ATTN: Document Control Desk
U.S. Nuclear Regulatory Commission
Washington, DC 20555-001**SUBJECT:**Davis-Besse Nuclear Power Station
Docket No. 50-346, License No. NPF-3
Completion of Required Action by NRC Order EA-12-051, Reliable Spent Fuel Pool
Instrumentation (CAC No. MF0960)

NRC Requests for Information
Page 1 of 28

By letter dated December 11, 2013, the Nuclear Regulatory Commission (NRC) issued an interim staff evaluation (ISE) and request for additional information (RAI) regarding the Davis-Besse Nuclear Power Station (DBNPS) overall integrated plan for implementation of NRC Order EA-12-051, Reliable Spent Fuel Pool Instrumentation. Subsequently, by letter dated March 26, 2014, the NRC staff transitioned to an audit-based review process that allowed the use of the licensee's ePortal to provide responses to the RAIs to support the staff's review process. FirstEnergy Nuclear Operating Company (FENOC) utilized the ePortal to provide the majority of RAI responses for DBNPS. The responses to the following RAIs were previously provided to the NRC via the FENOC ePortal: RAI-4(b) schematic, RAI-5, RAI-7, RAI-8, RAI-10(b), RAI-11, RAI-12, RAI-13, RAI-14, and RAI-15. The previousl

DBNPS Critical Level Elevations and Measurement Range

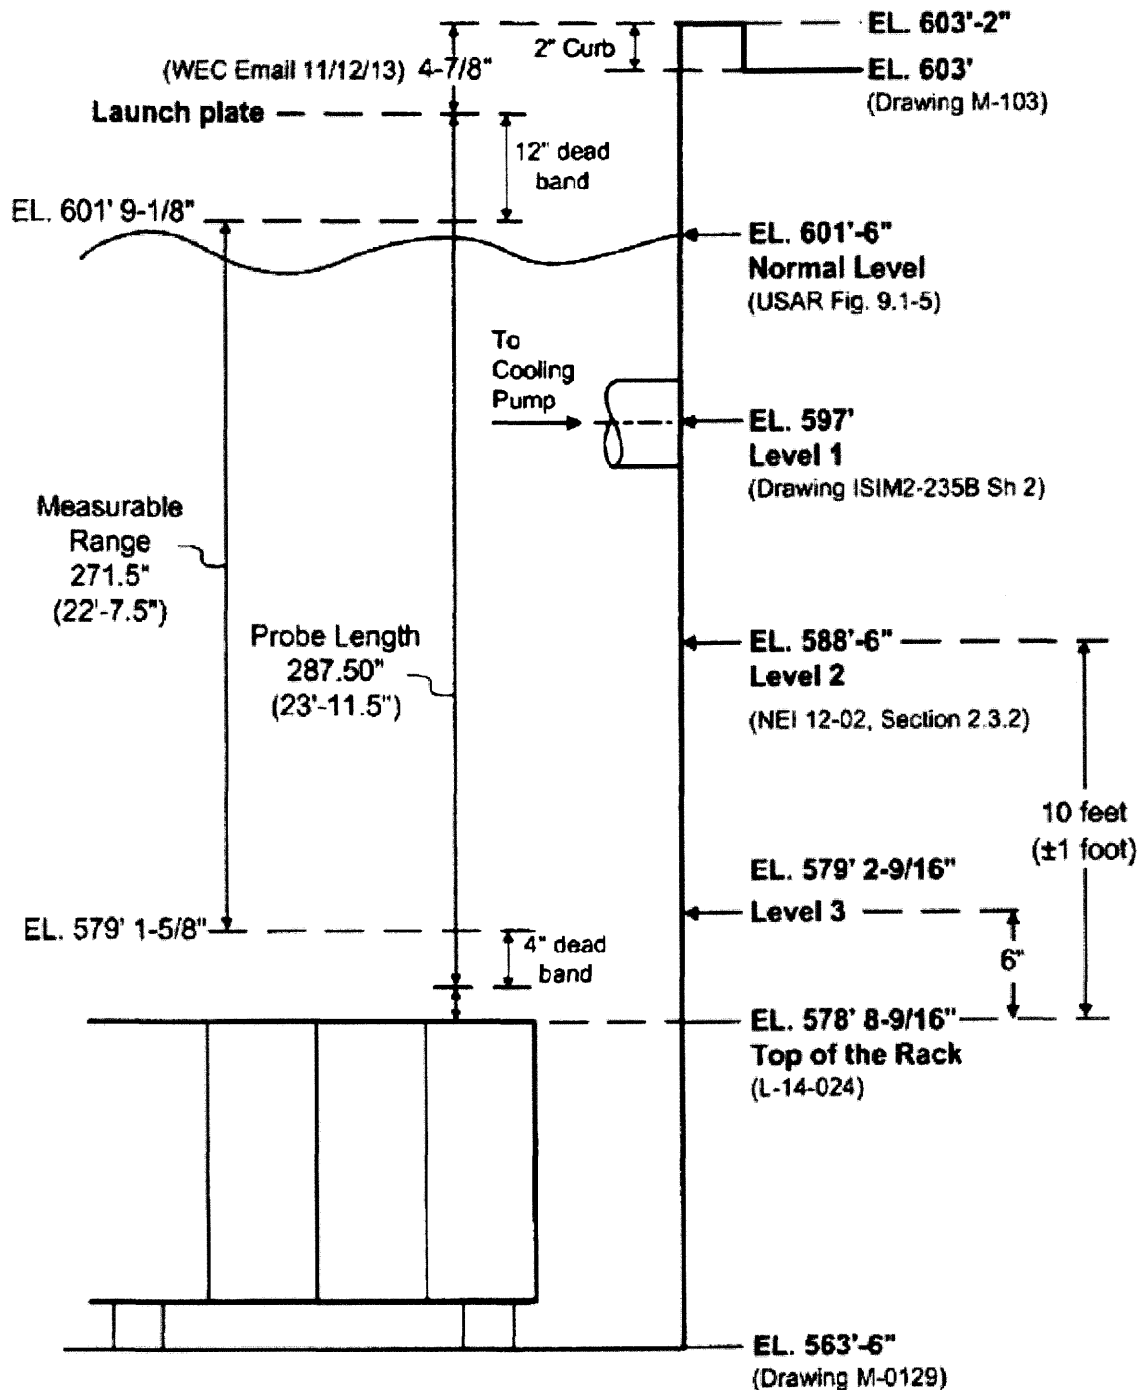
RAI-2:

Please provide a clearly labeled sketch depicting the elevation view of the proposed typical mounting arrangement for the portions of the instrument channel consisting of permanent measurement channel equipment (e.g., fixed level sensors and/or stilling wells, and mounting brackets). Indicate on this sketch the datum values representing Level 1, Level 2, and Level 3, as well as the top of the fuel racks. Indicate on this sketch the portion of the level sensor measurement range that is sensitive to measurement of the fuel pool level, with respect to the Level 1, Level 2, and Level 3, datum points.

The response to this RAI was provided by FENOC letter dated February 27, 2014. Subsequently, more refined measurements were obtained for the top of fuel rack and bottom of measurement range. An updated sketch is provided below.
